Schedule I
Reconstruction of Taxiway F

Transmitted herewith is Addendum **No. 2** to the Issued for Bid Contract Documents, Specifications and Plans dated May 25, 2023 for Improvements to the Oxnard Airport.

**ADDENDUM NO. 2 TO
CONTRACT DOCUMENTS, SPECIFICATIONS AND PLANS
FOR IMPROVEMENTS TO THE
OXNARD AIRPORT
OXNARD, CALIFORNIA
AIP PROJECT NO. 3-06-0179-043-2023
COUNTY OF VENTURA DOA SPEC. NO. OXR 23-03, PROJECT NO. OXR-150**

ELECTRICAL DEMOLITION PLAN				SHEET NAME
STA. 124+00 TO STA. 137+00				E102
RUNWAY 7/25				SHEET NO.
DRAWING NO.				78 of 89
AIP PROJECT NO. 3-06-0179-043-2023	JVIATION PROJ. NO. 2023.OXR.01	SPEC. NO. DOA 23-03	COUNTY PROJ. NO. OXR-150	DRAWING NO. 1663-DOA

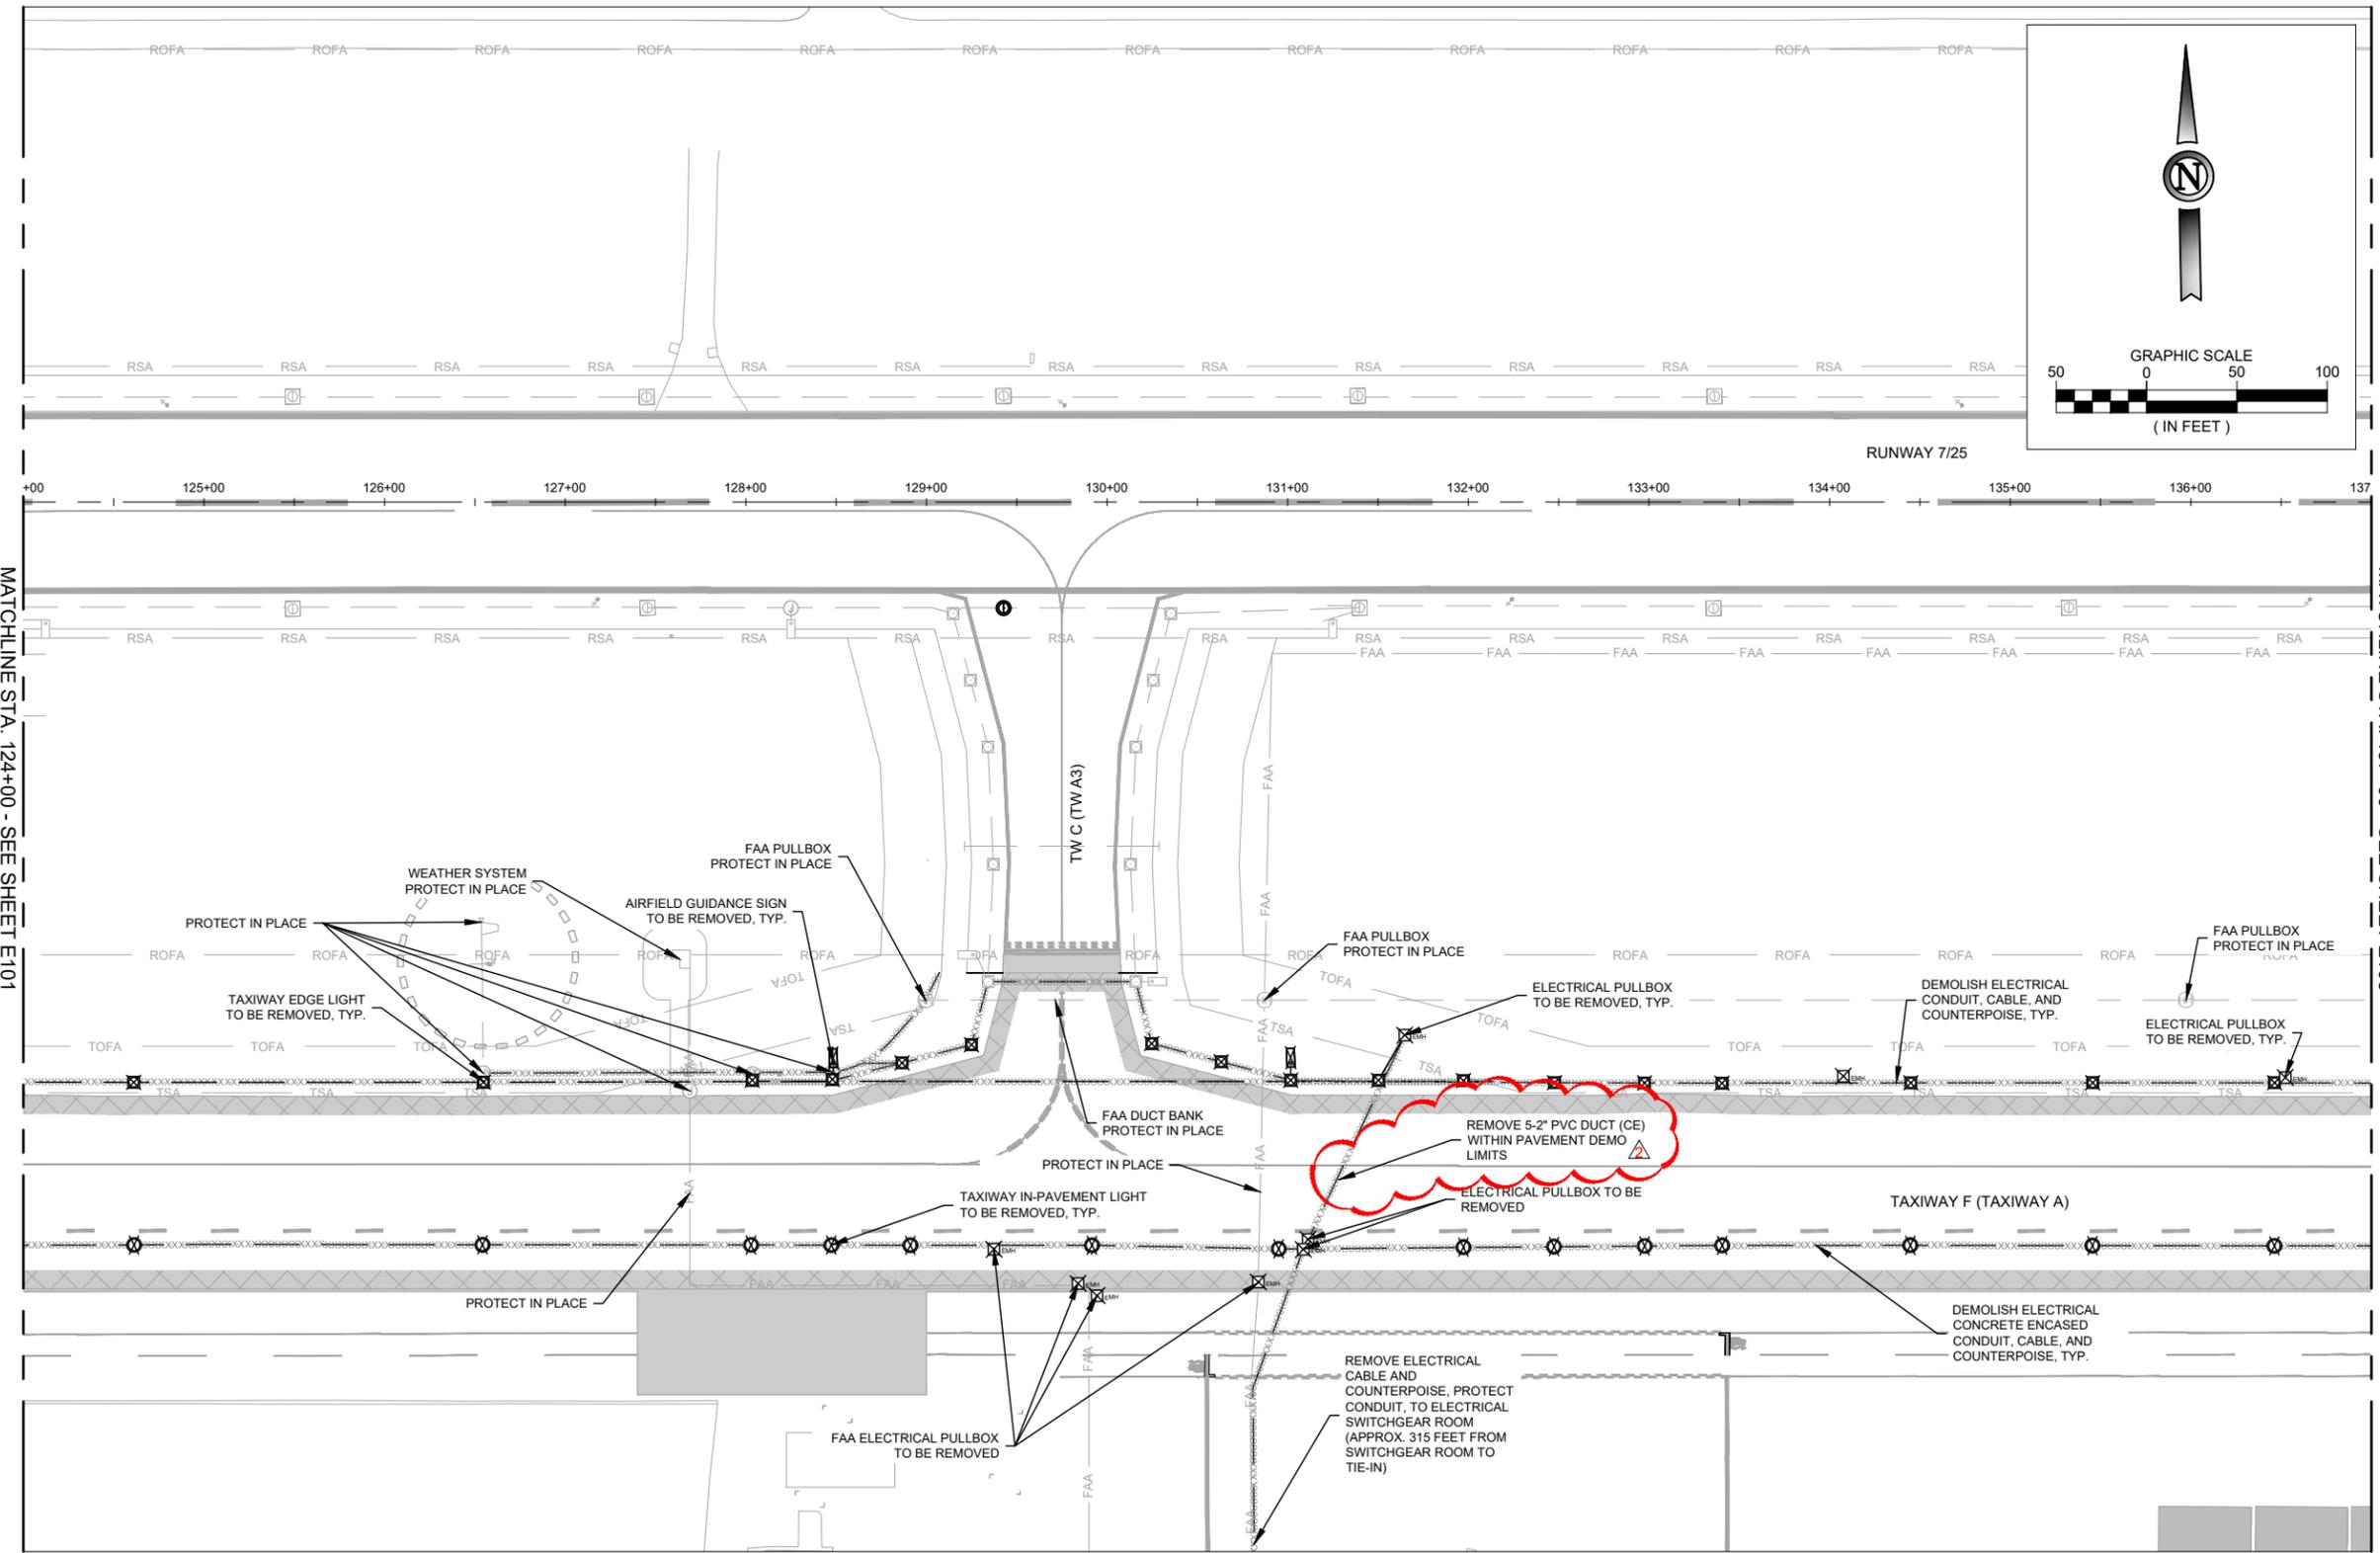
Sheet E102, ELECTRICAL DEMOLITION PLAN STA. 124+00 TO STA. 137+00 RUNWAY 7/25. A note was added showing the demolition of the 5-2" PVC Duct within the pavement demo limits.

- 6) Question: On Plan Sheet E102, please clarify means and methods for removal of conduit and wire crossing under existing Taxiway F (Taxiway A).

Justification: This duct bank will be demolished during the project.

Answer: This duct bank shall be removed during the project. The limits of removal shall be within the pavement removal limits.

ELECTRICAL LAYOUT PLAN
 STA. 98+00 TO STA. 111+00
 RUNWAY 7/25

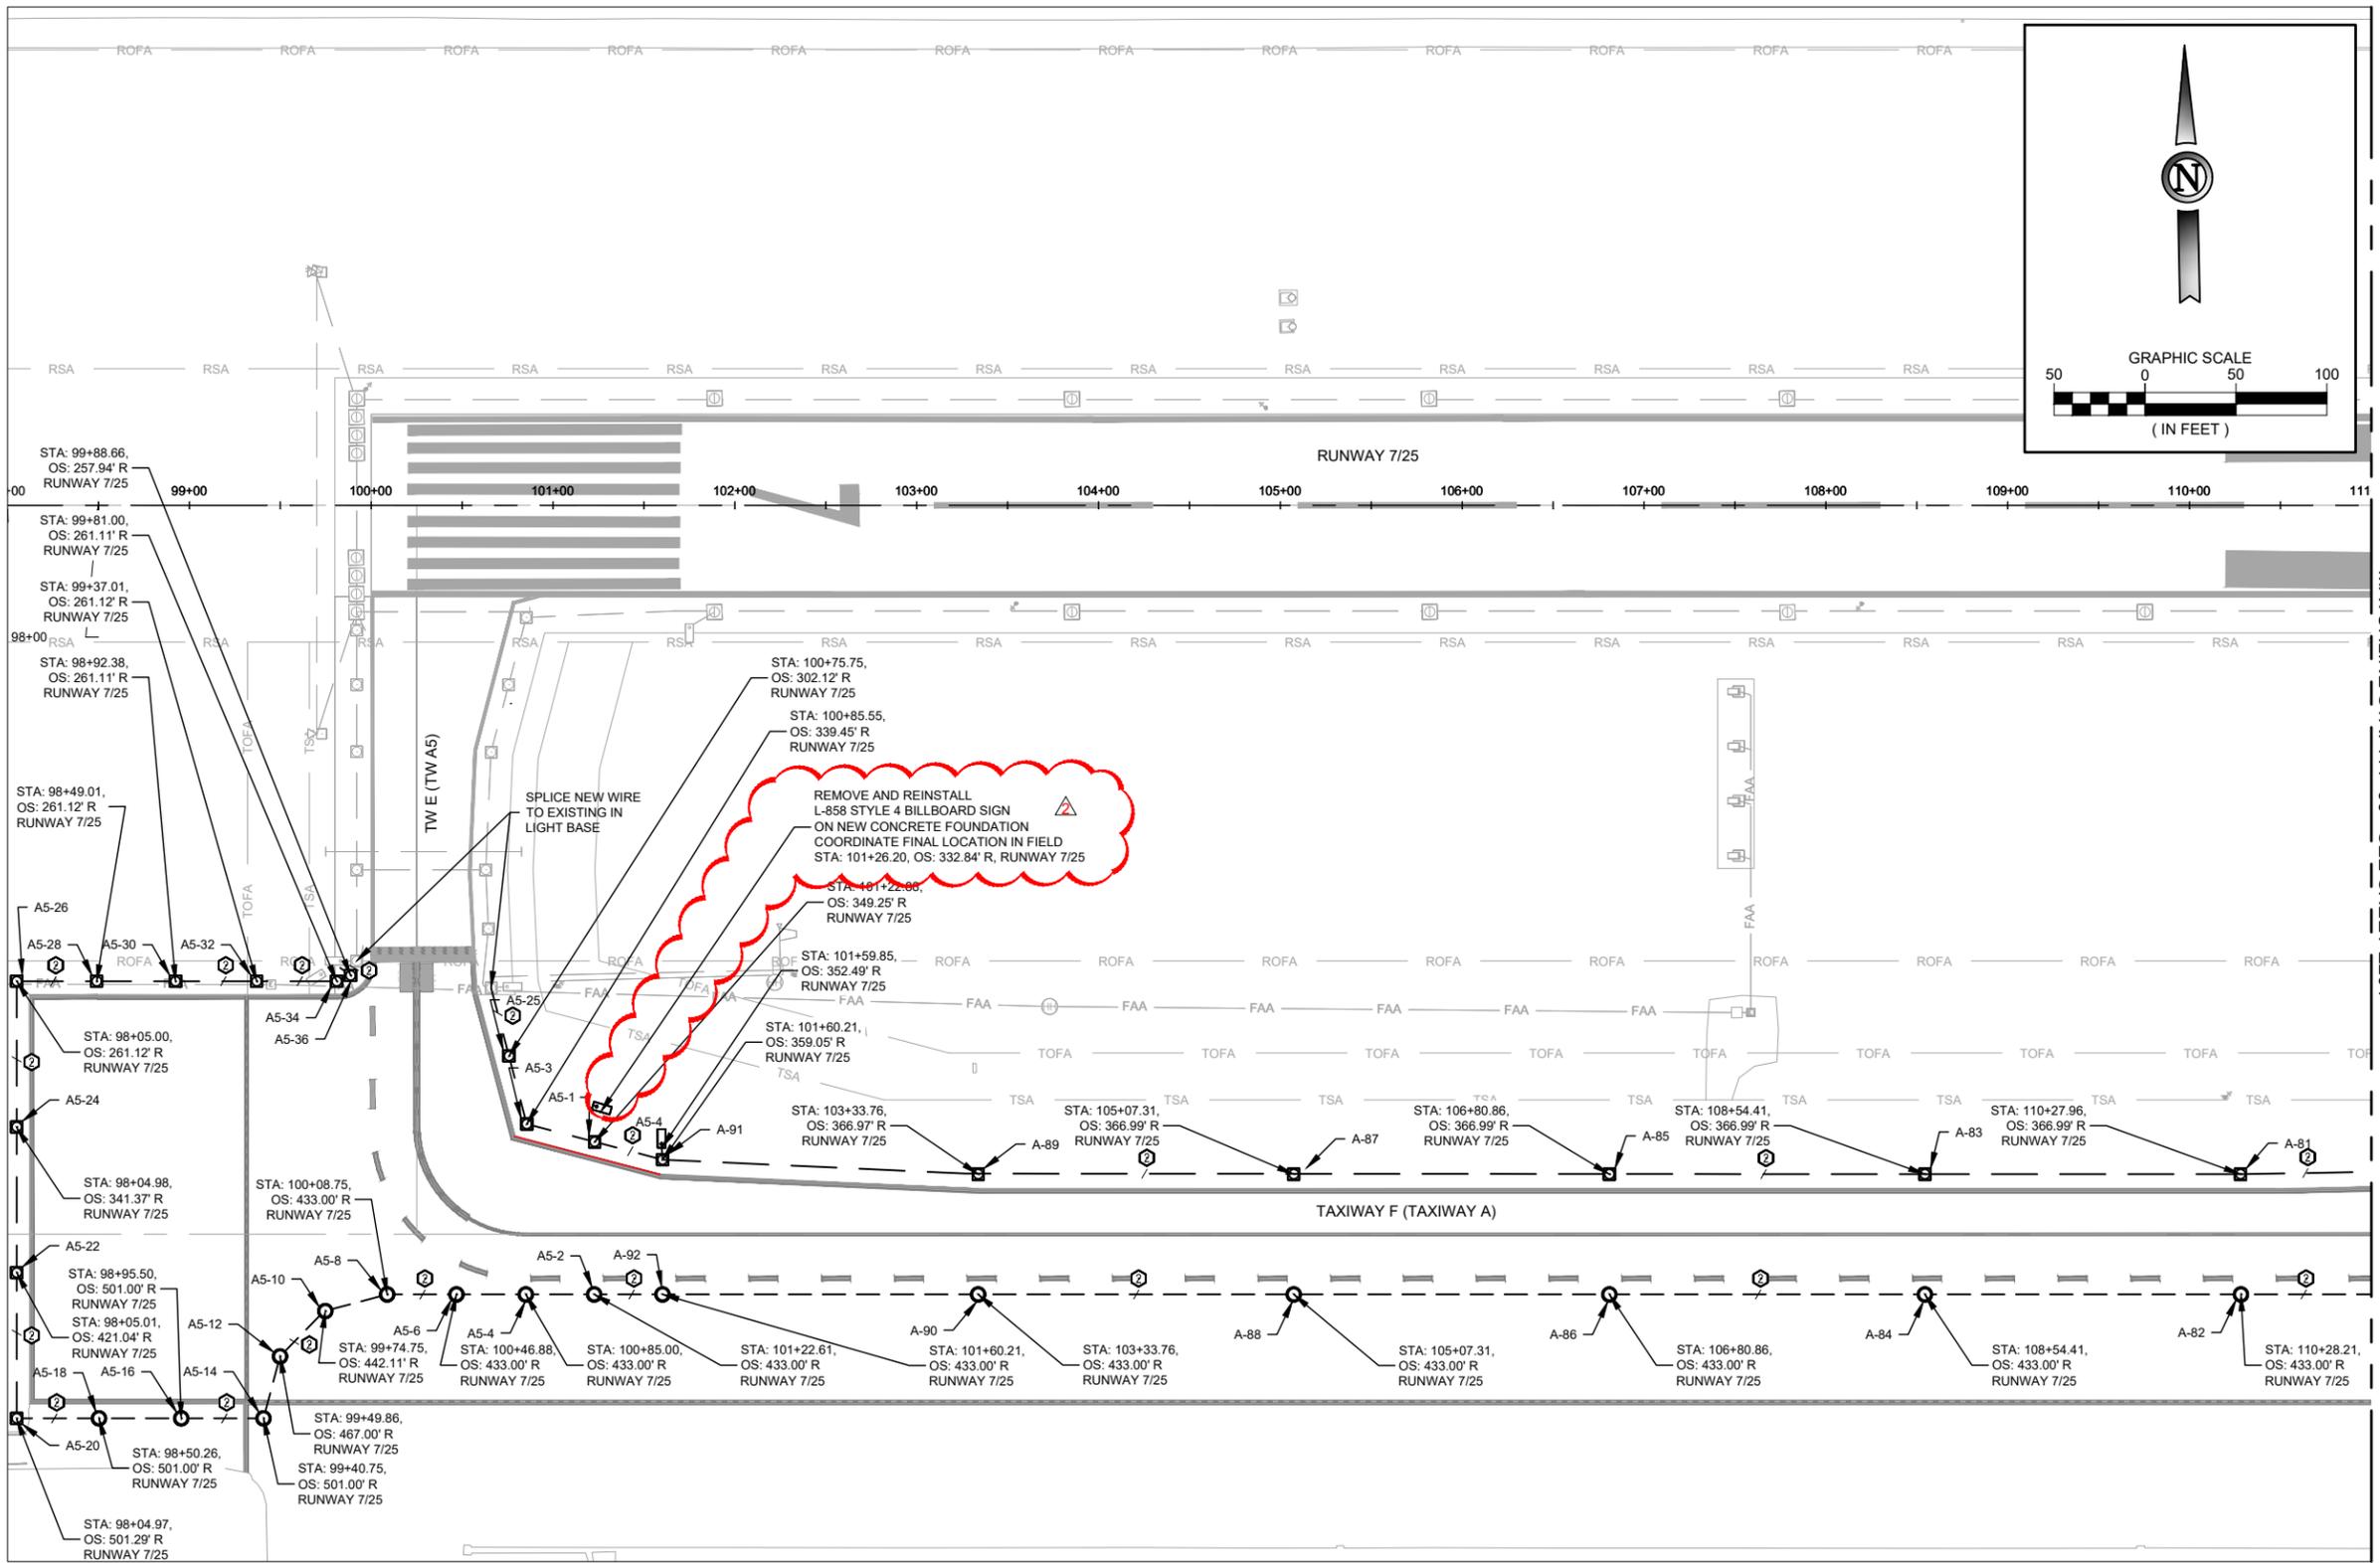
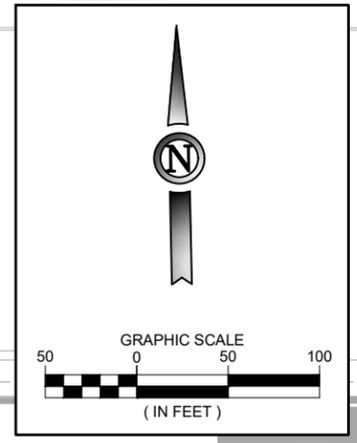
Sheet E200, ELECTRICAL LAYOUT PLAN STA. 98+00 TO STA. 111+00 RUNWAY 7/25. The reinstatement of an unlighted guidance sign was added to the plans.

Justification: The sign will be removed and reinstalled due to the change in pavement geometry.
